South Texas Project
Units 3 and 4
Docket Nos. 52-012 and 52-013
Response to Request for Additional Information

Attached is the STP Nuclear Operating Company (STPNOC) response to Request for Additional Information (RAI) question 02.04.05-10 in RAI letter number 334 related to COLA Part 2, Tier 2, Section 2.4S.5, "Probable Maximum Surge and Seiche Flooding." This letter provides the complete response to RAI letter number 334. The attachment provides the response to the following RAI:

02.04.05-10

Figure 1, ADCIRC Results for the PMH with a Northwest Track passing West of the STP Site

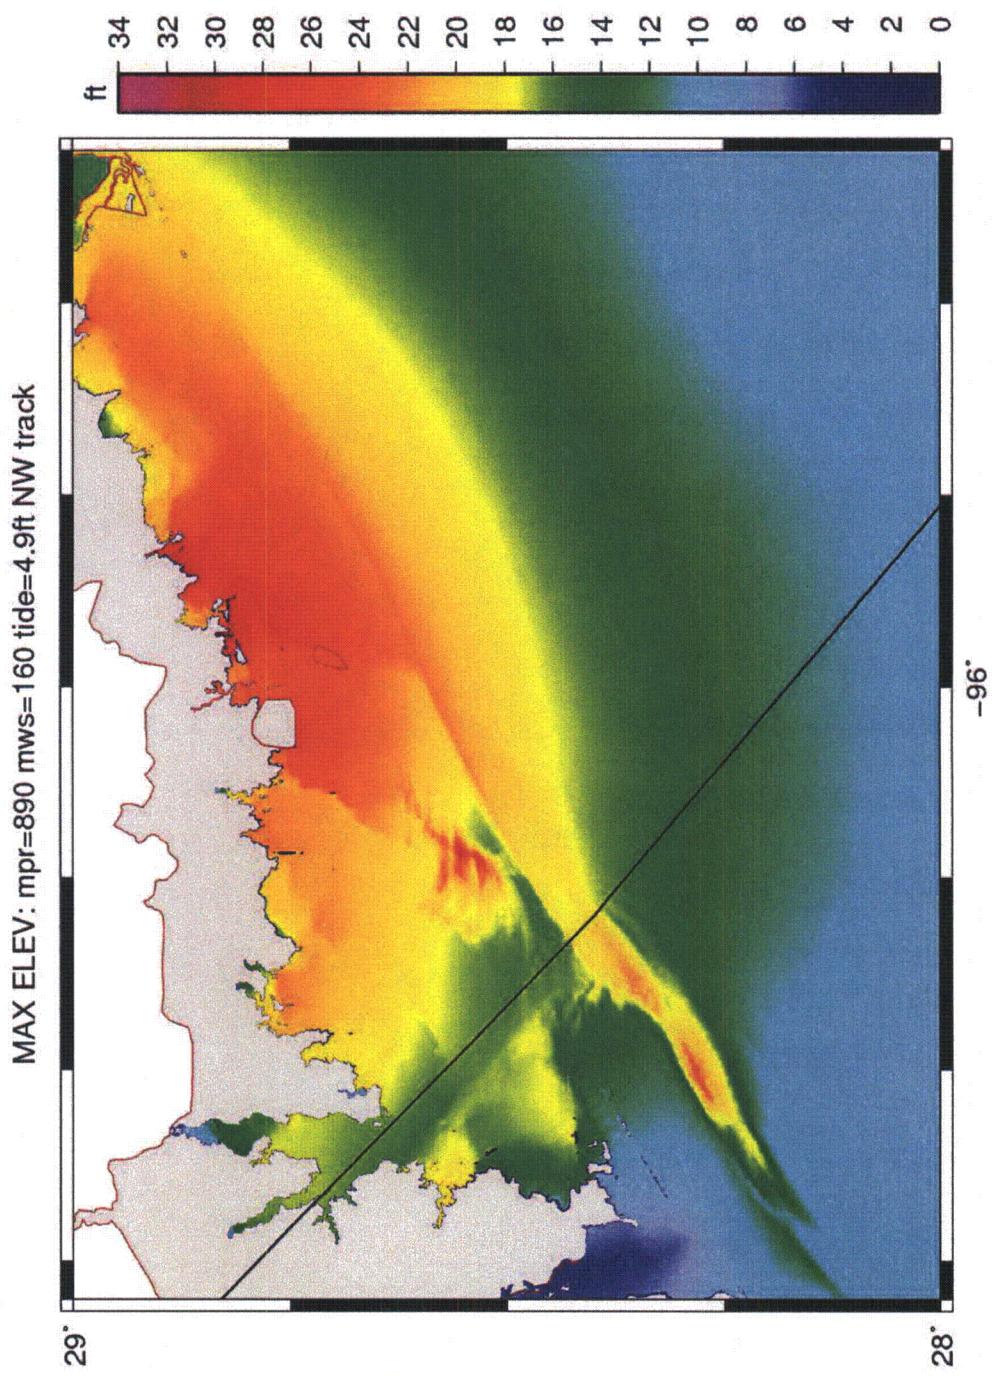
- (1) The applicant's estimation of the effects of the Probable Maximum Storm Surge (PMSS) are based on the estimation of storm surge using two approaches: (i) use of the SURGE model to estimate storm surge in the Gulf of Mexico and applying the estimated storm surge as a boundary condition in HEC-RAS modeling software to predict water surface elevations near the STP site, and (ii) extrapolation from storm surge values obtained from the Sea, Lake, and Overland Surges from Hurricanes (SLOSH) model near the STP site for Category 1 through 5 hurricanes in the Gulf of Mexico to estimate the storm surge for probable maximum hurricane (PMH) conditions. The applicant-estimated PMSS water surface elevation at the STP site was produced by the second approach above (31.1 ft MSL) and did not reach the site grade (34 ft MSL).

Through independent confirmatory analysis, the staff determined that the PMSS water surface elevation of 31.1 ft MSL, obtained by the applicant using the extrapolation procedure described above may not be technically valid or conservative. Based on its independent estimation of PMSS water surface elevations, the staff determined that the outer face of the MCR north embankment may be subject to wave action from PMSS. Because the outer face of the MCR embankment is only grass-lined and not protected by reinforced soil-cement or riprap, the staff postulated that the MCR embankment could possibly fail during the PMSS event. If this scenario were to occur, the MCR breach flood would coincide with the PMSS event.

Please provide the following information: (a) an analysis of the PMSS event using a conservative approach such as those predicted by a storm surge model (e.g., SLOSH) with input from appropriate PMH models, (b) reasons why exposure of the outer face of the MCR embankment to the PMSS event would not lead to a breach, and (c) if an MCR breach is postulated under PMSS conditions, a revised estimate of the design-basis flood water surface elevation at the STP site.

- ADCIRC more accurately models topographic features that block or accelerate storm surge flooding (e.g. highways) than SLOSH. This feature of ADCIRC is particularly relevant to STP because the barrier islands along the Texas Coastline south of the STP site and the levee surrounding the City of Matagorda southeast of the STP site influence predicted storm surge levels at the STP site (see Figure 1 and Figure 2).

Model 5: This STP confirmatory analysis is based on ADCIRC Version 49 and Texas Grid Version 13 and assumed that PMH intensity started to decay only after landfall. This model predicted the PMSS at the Gulf Coast is 21.5 feet MSL. This model predicted the PMSS at the STP site, including wave runup, is 26.5 feet MSL. The predicted maximum surge at STP is less than the site grade (Figures 1 and 2).
